UNITED STATES PATENT AND TRADEMARK OFFICE

APPLICATION NO.	FILING DATE	FIRST NAMED INVENTOR	ATTORNEY DOCKET NO.	CONFIRMATION NO.
10/625,023	07/23/2003	Larry C. Hardin	WOG 1387.0025	8216

Office Action Summary

This is an office action for serial number 10/10/625,023, in response to Amendment filed on May 2, 2005.

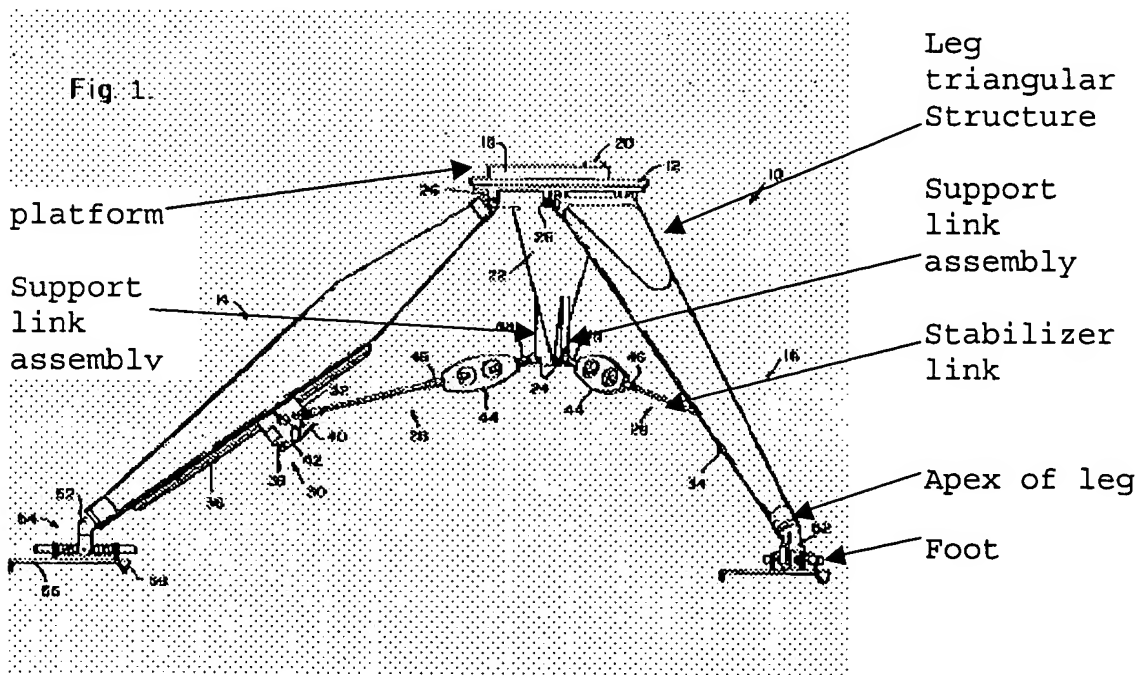
Claims 1, 2, 4-8, 10-13, and 19 are rejected, as best understood, under 35 U.S.C. 103(a) as being unpatentable over Weber 4,199,123 in view of Dalton 2,668,682 in Fontana et al. (Fontana) 4,339,842. Weber discloses a platform (18), three legs (14, and 16), three support link assemblies (near 24), three sets of stabilizer links (28), and three foot members (56). The three support link assemblies are each triangular shaped members which connect the stabilizer links to the central point below the platform therefore making each a support link assembly. Weber discloses all of the limitations of the claimed invention except for the legs being a pair of rods, three casters and stabilizer members. Dalton teaches that it is known to have a platform base (above 16), three hollow cylindrical members (16), three foot members (17), a set of stabilizer links (18). It would have been obvious to one having ordinary skill in

the art to have modified Weber to have the legs being the pair or rods as taught by Dalton for the purpose of reducing the weight of the tripod therefore making it easier to transport. Fontana teaches that it is known to have casters (9) having a stabilizer member (16) being a threaded bolt (38) received in a threaded bore (24) of a threaded sleeve (22) of the foot extending between a pair of wheels (14 and 15) for engaging the ground. It would have been obvious to one having ordinary skill in the art to have modified Weber in view of Dalton to have included the wheel and stabilizer as taught by Fontana for the purpose of transporting the tripod to various locations and once the desired location has been reached preventing the wheels from moving therefore stabilizing the tripod.

In response to the applicant's arguments that Weber does not disclose a support link assembly the examiner hereby traverses this argument. Weber clearly teaches a support link being three support link assemblies as indicated near reference number 24 of Weber figure 1. The support link assemblies comprise three members each having a triangular shape with an apex that is located at the central point which is understood by the examiner to be the point at the end of element 22. This clearly provides the central point as claimed by the applicant in claim 1 where the three stabilizer links (28) are connected to the three support links assemblies (shown in the enclosed figure).

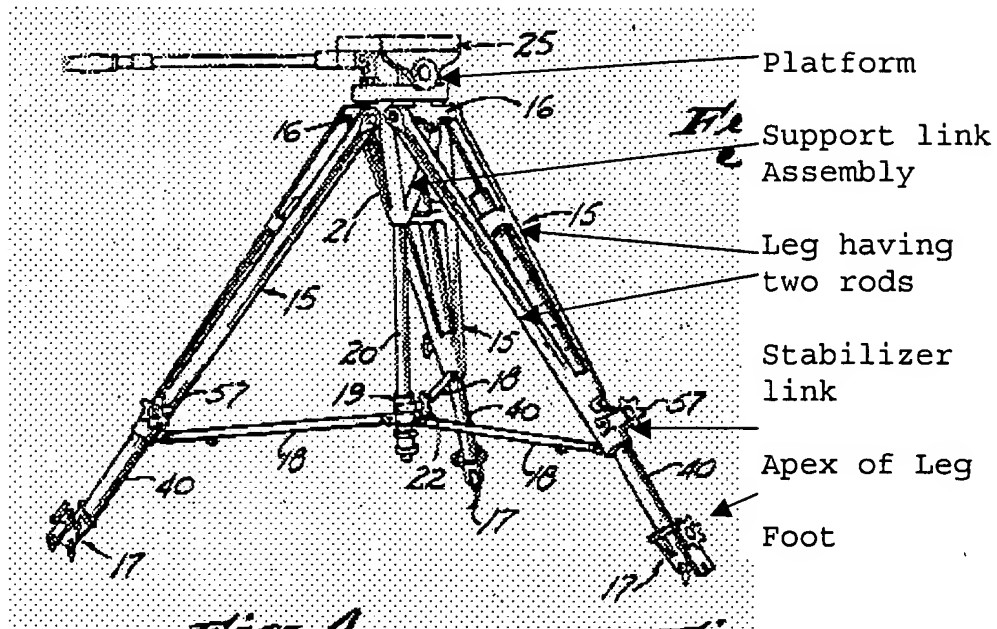
Claims 4-8, 10-12, and 19 are rejected, as best understood, under 35 U.C.S. 103 (a) as being unpatentable over Dalton 2,668,682 in view of Fontana 4,339,842.

In response to the applicant's arguments that Dalton does not disclose that each leg assembly comprises a pair of rods the examiner hereby traverses this argument. Dalton teaches that the leg assembly 15 is composed of two rod members (see enclosed figure 1) which are attached at opposite sides of the cylindrical members (16) of the platform base (near 25) at one end (top of leg) and at the other end (bottom of leg) form an apex to couple with the foot (40).
